Rezoning Application: PD 25-0274 (REV)

Development Services Department

AGENCY REVIEW COMMENT SHEET

10: Zoning Technician, Development Services Department		DATE: 6/09/2025	
	WER: Richard Perez, AICP, Executive Planner ING AREA/SECTOR: SM/CENTRAL	AGENCY/DEPT: Transportation PETITION NO: PD 25-0274	
	This agency has no comments.		
	This agency has no objection.		
X	This agency has no objection, subject to listed or att	ached conditions.	
	This agency objects, based on the listed or attached conditions.

ZHM HEARING DATE: BOCC LUM MEETING DATE:	June 16, 2025 August 12, 2025	Case Reviewer: Sam Ball			
0.0 DDODOCED CITE DI A	NI/FILLI				
8.0 PROPOSED SITE PLAN (FULL)

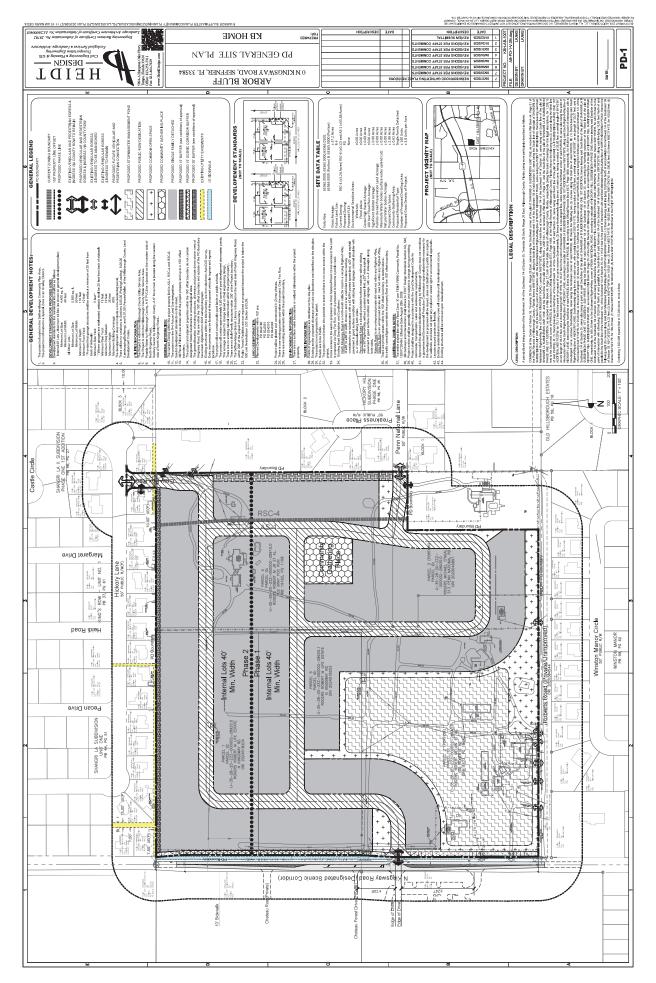
Prior to Certification, the applicant shall <u>update the general legend to change "proposed 30' buffer" to "proposed 35' buffer"; remove "see conditions of approval" statements from the general legend; and revise the General Notes #33 as follows: "Access to the east is proposed via Penn National Road. Access to the north is proposed via Gray Fox Run, which is proposed to become a public road." [Replace the words "cross access" with "access". Cross access is not the same as access and is not applicable to residential subdivisions.]</u>

ZHM HEARING DATE: BOCC LUM MEETING DATE:	June 16, 2025 August 12, 2025	Case Reviewer: Sam Ball
8.0 PROPOSED SITE PLAN (FULL)

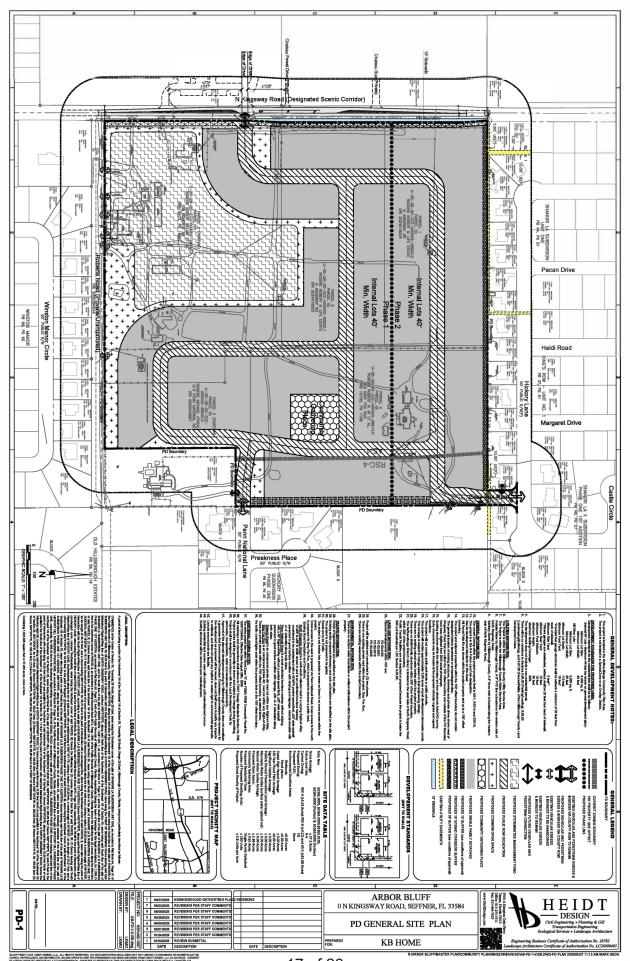
Prior to Certification, the applicant shall <u>update the general legend to change "proposed 30' buffer" to "proposed 35' buffer"; remove "see conditions of approval" statements from the general legend; and revise the General Notes #33 as follows: "Access to the east is proposed via Penn National Road. Access to the north is proposed via Gray Fox Run, which is proposed to become a public road." [Replace the words "cross access" with "access". Cross access is not the same as access and is not applicable to residential subdivisions.]</u>
